## **NOTICE OF PUBLIC MEETING**

## INSPIRED KIDS ACADEMY

**RE:** Inspired Kids Academy - Preliminary Plat and Site Plan

CITY OF VAN METER  
INSPIRED KIDS ACADEMY  
PRELIMINARY PLAT/SITE PLAN  
REVIEW COMMENTS

**PAVING PLAN**

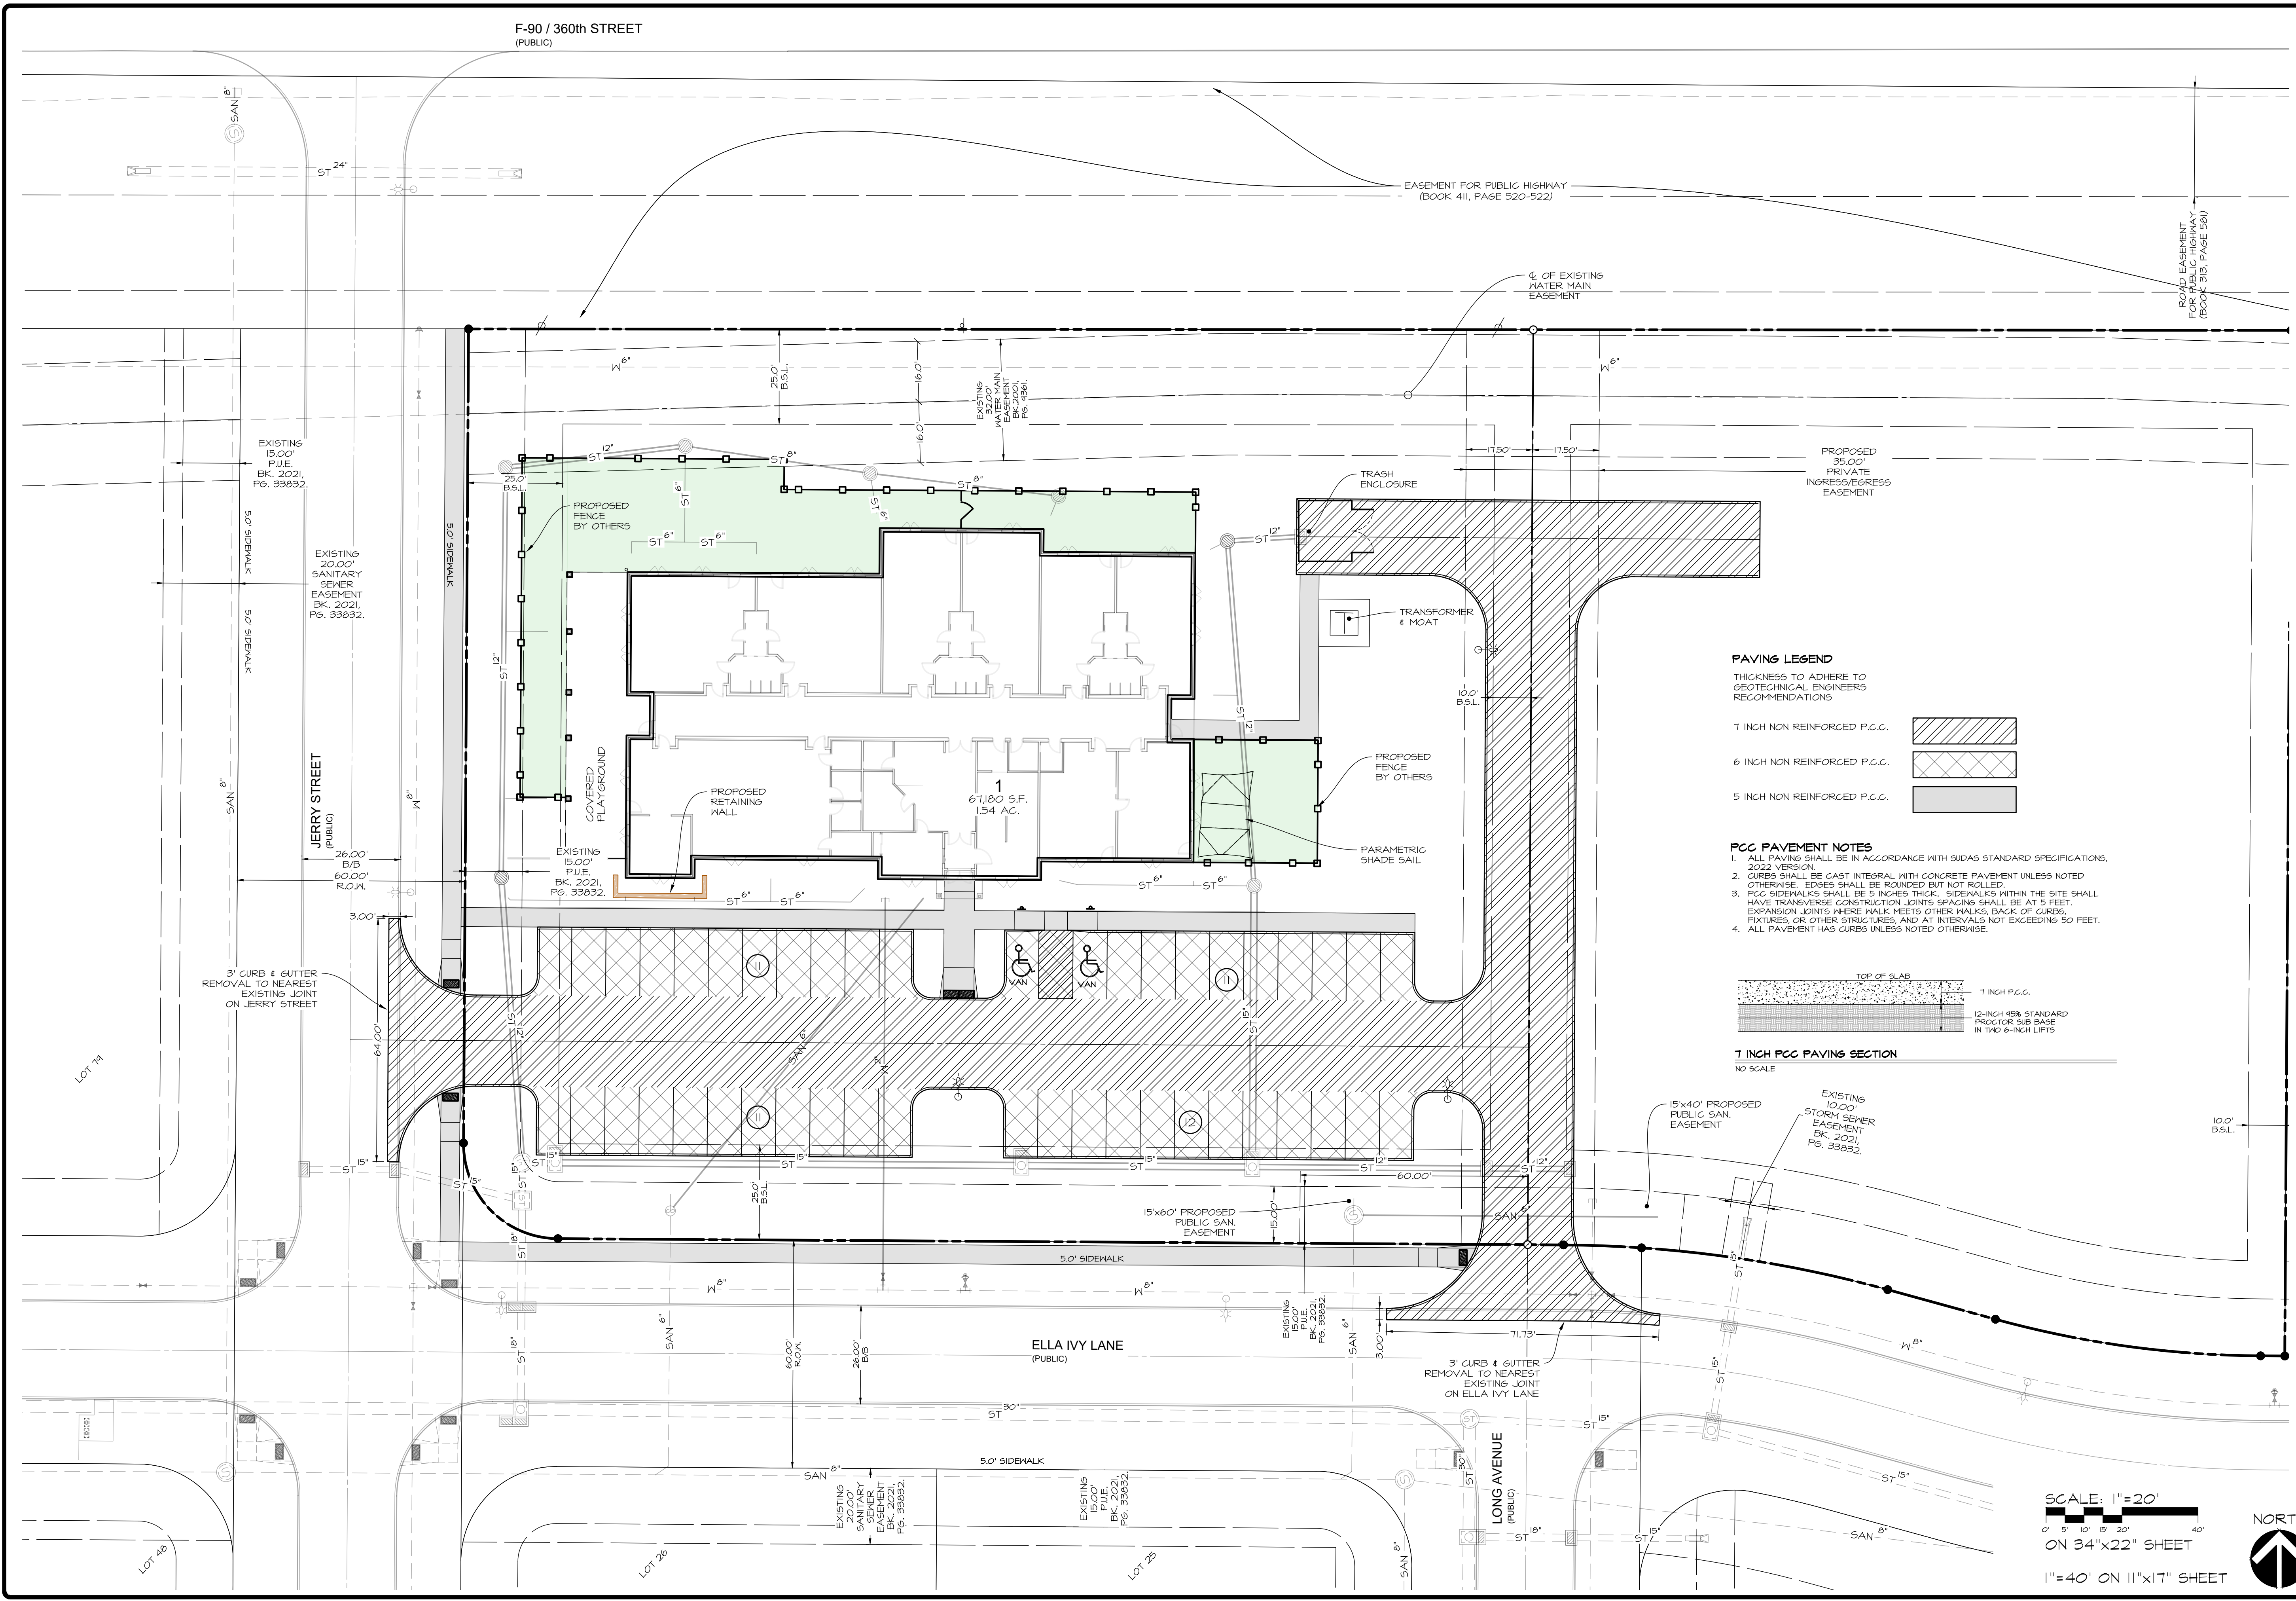
22. The site plan shows the construction of proposed sidewalks along the east side of Jerry Street and the north side of Ella Ivy Lane.
23. The site plan includes ADA ramps on both sides of the driveway on Jerry Street.

24. The site plan only shows an ADA sidewalk ramp on the west side of the shared drive. On the east side of the shared drive it appears a full height curb is constructed. The site plan appears to indicate in this area the driveway grades are compatible with ADA grades for a future ramp on the north side of the shared drive.

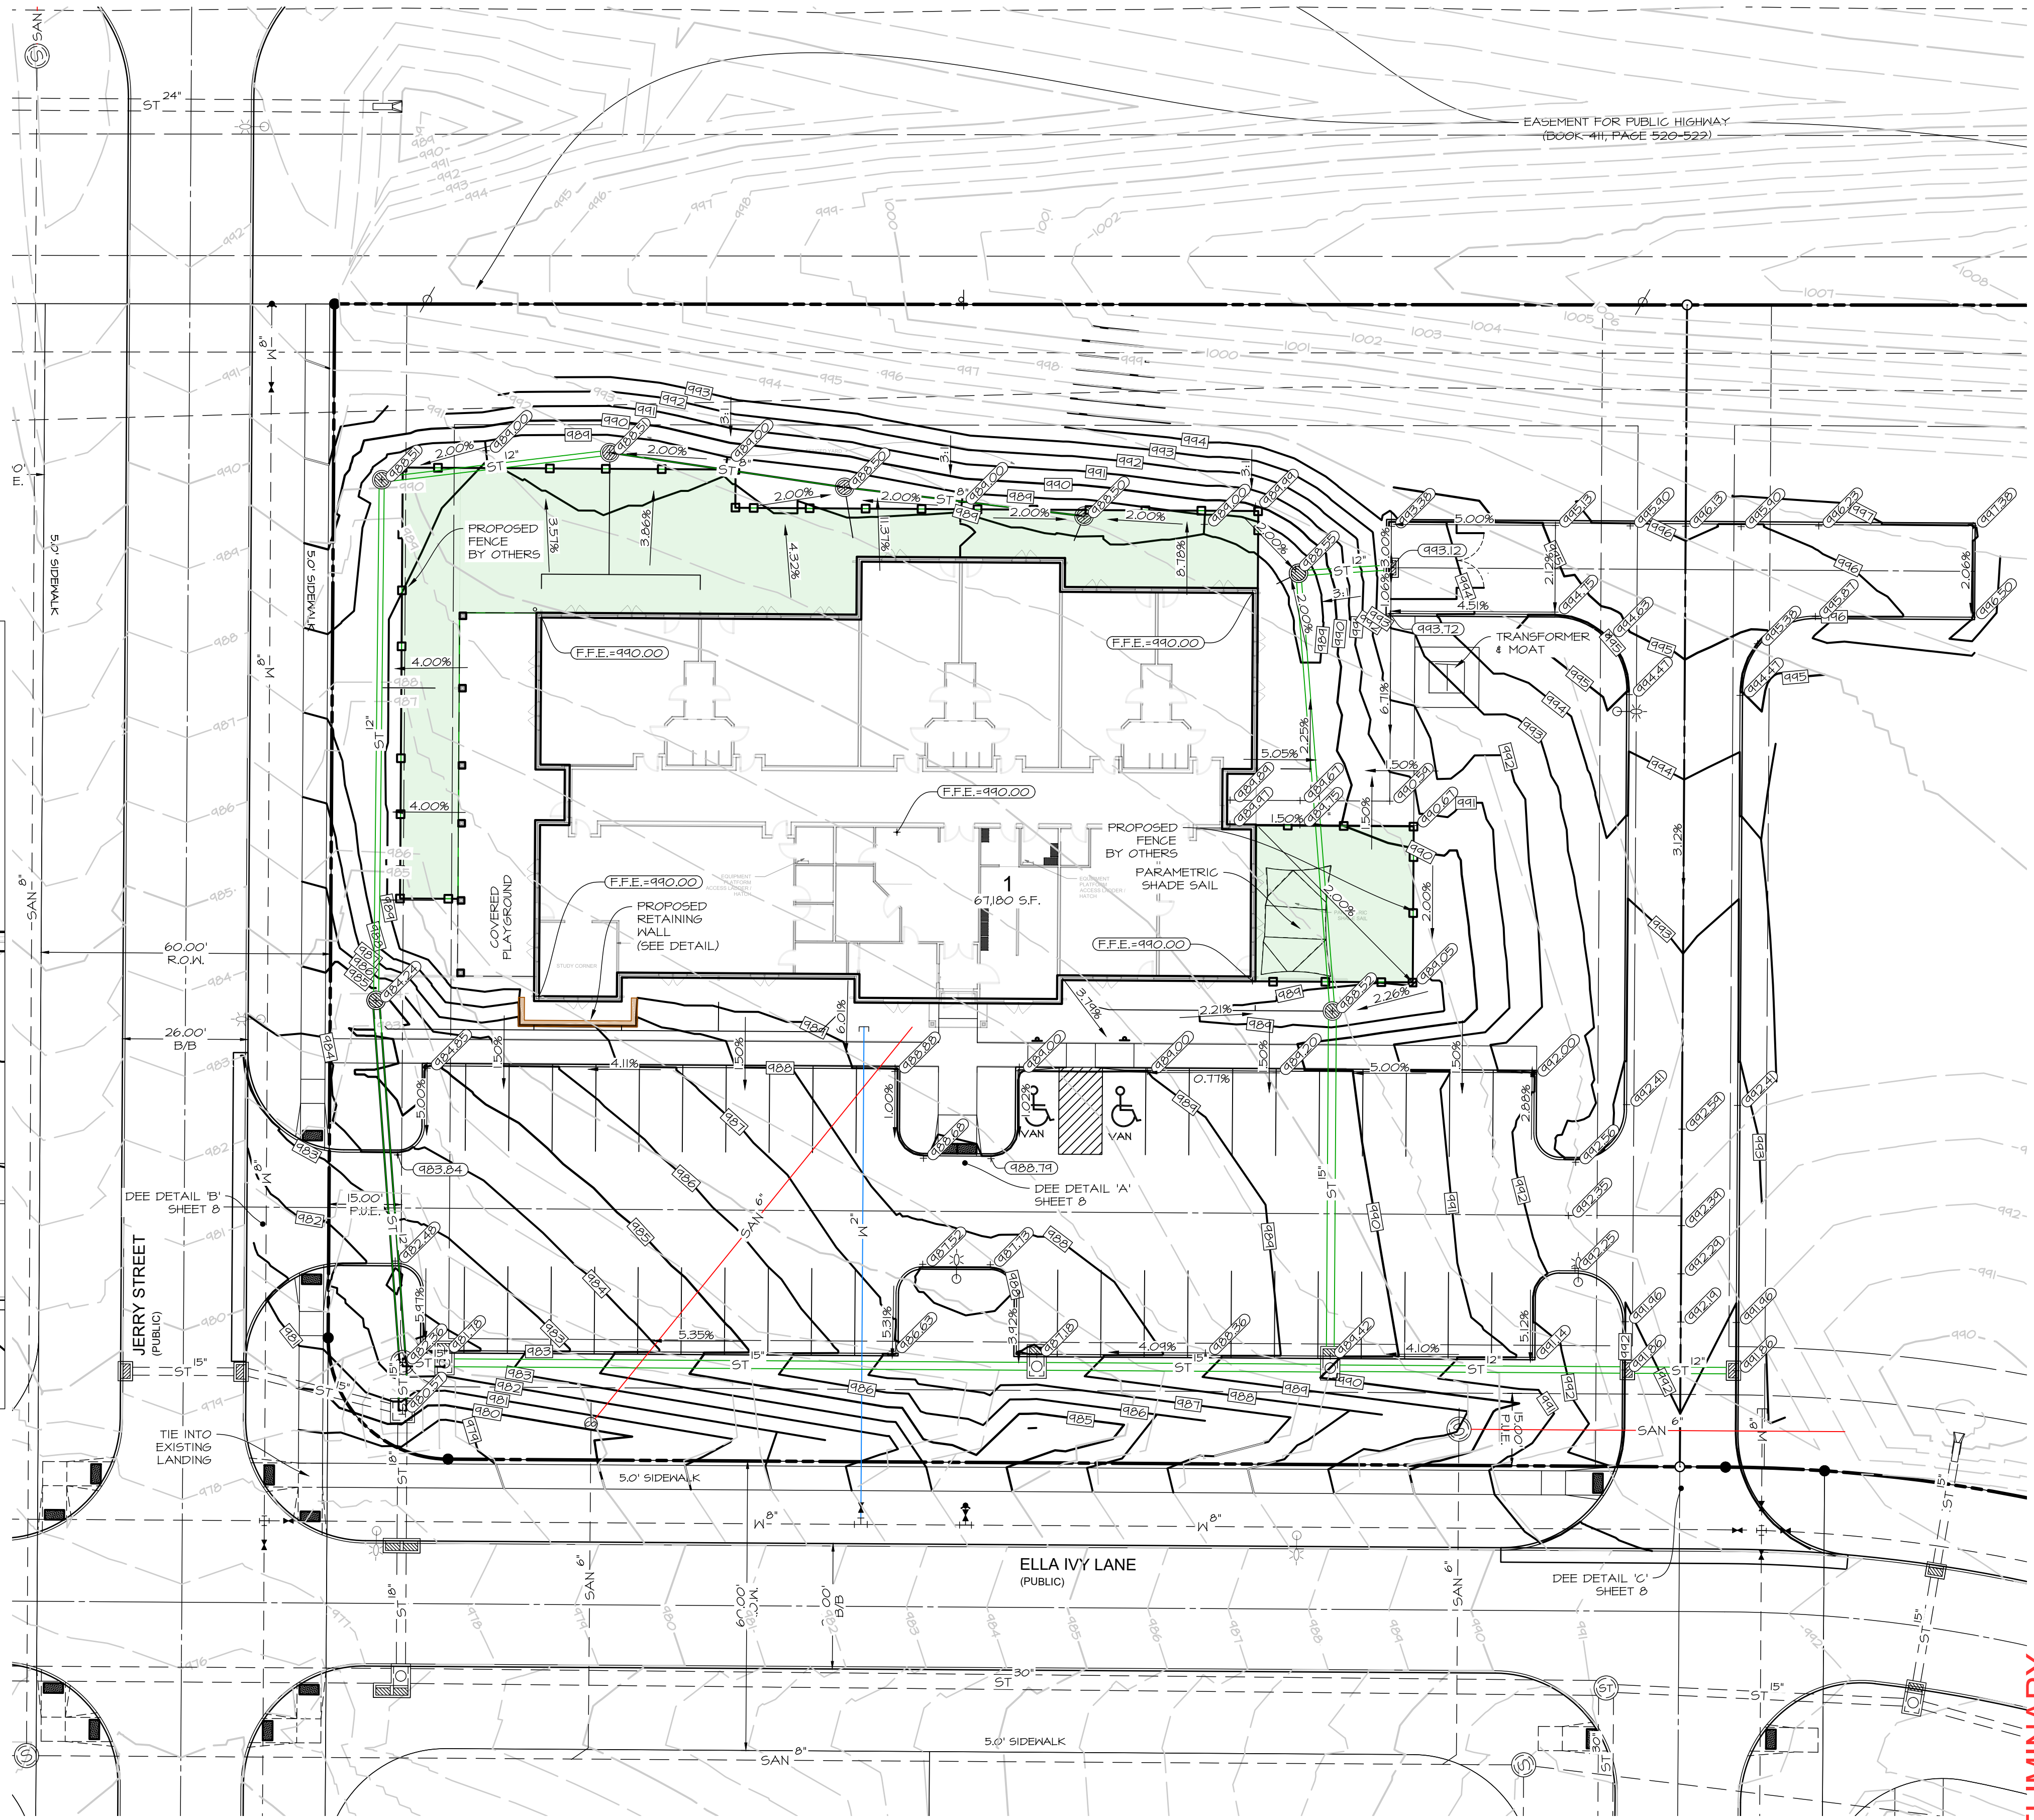
27. The site plan shows the grading plan. Generally the site slopes from northeast to southwest.
28. The drainage in the easterly part of the site is intercepted by the two legs of the storm sewer along the north side of Ella Ivy Lane. This storm sewer also intercepts the runoff from the eastern part of the parking lot.
